What Empirical Research has Established about Wind Farm Visual Impact

Dr Michael Crawford 6th November 2016

The research based distances for thresholds for key levels of VI are **many** times larger than thresholds proposed by the NSW Department of Planning and Environment in its draft VI Assessment Bulletin. **The Department's proposed thresholds are repudiated by the consistent research findings.**

Figure 1

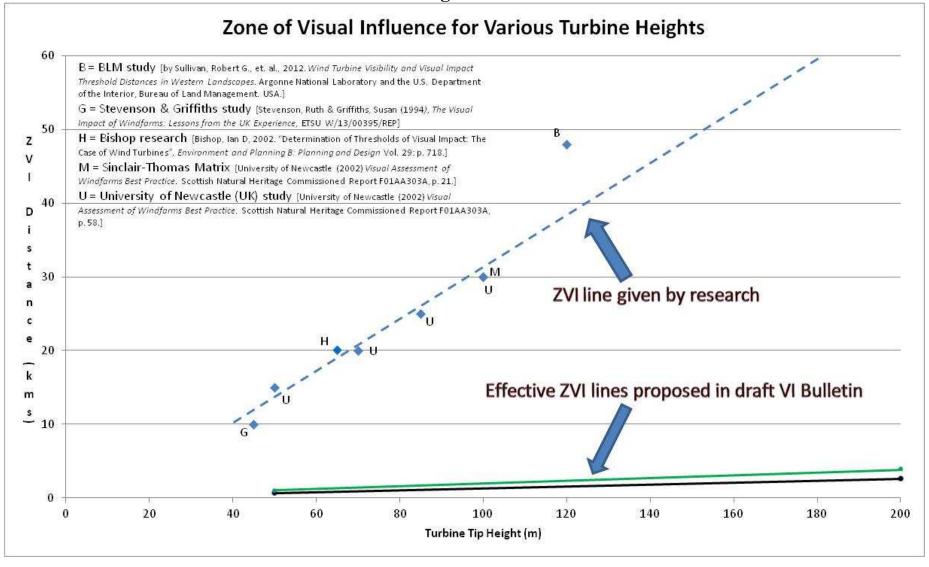
In its draft VI Assessment Bulletin, the DPE introduced two lines. One set a threshold to be used in "pre-assessment" by wind farm proponents. It is the black line in Figure 1.

The second threshold is marked by the green line in Figure 1. The draft VIAB requires that for what the Bulletin deems the most sensitive viewing situations, if a turbine is closer than the green line threshold, the developer must provide justification. Note, they are not prohibited from placing turbines closer than that threshold – but must provide a justification.

What is patently obvious from Figure 1 is that these new, shrunken, ZVI lines are minute compared to where multiple empirical studies have determined they should be (the dotted line).

For a 50m turbine, the DPE green line sets the ZVI threshold at 1 km. The empirical research explicitly indicates a ZVI threshold of 15 kms for turbines that height. So the DPE proposed ZVI is *one fifteenth (1/15 th)* of what empirical research indicates. That same relationship (1/15 th) also applies at all other heights.

Thus the DPE has proposed a ZVI (which it now refuses to call by that name) that is at most only 1/15 th of the research-based ZVI distance and in many cases much less than that.

Figure 2

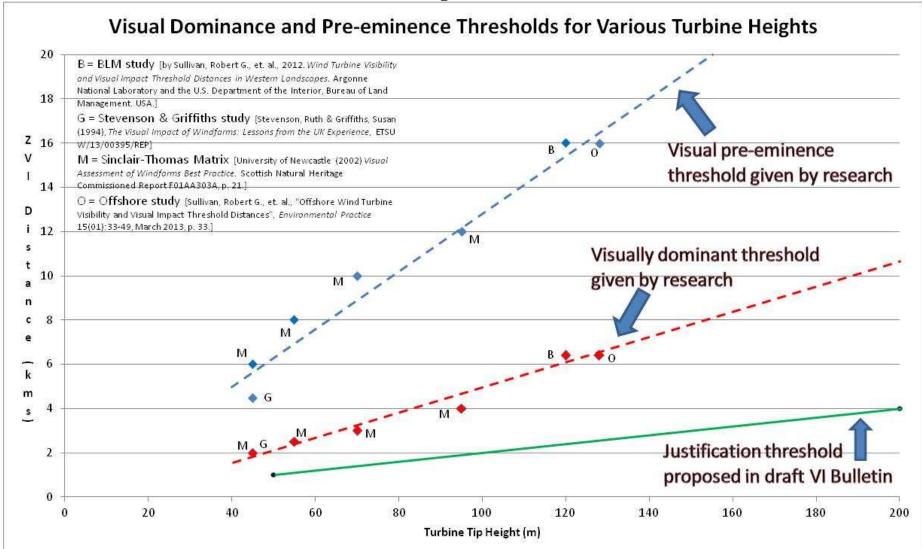
Figure 2 makes even clearer why the DPE's suggestion is intellectually indefensible. That diagram includes the DPE's green line (for formal assessment) threshold. It also includes two other thresholds defined by empirical research and, for each, shows the individual points determined by the various studies.

The dotted blue line marks the threshold for *visual pre-eminence* (the term defined in the BLM study). The dotted red line is the threshold for *visual dominance*.

As can be seen, DPE's ZVI threshold is set at about 1/6 th of the threshold for *visual pre-eminence* and about 40% of the threshold for *visual dominance*.
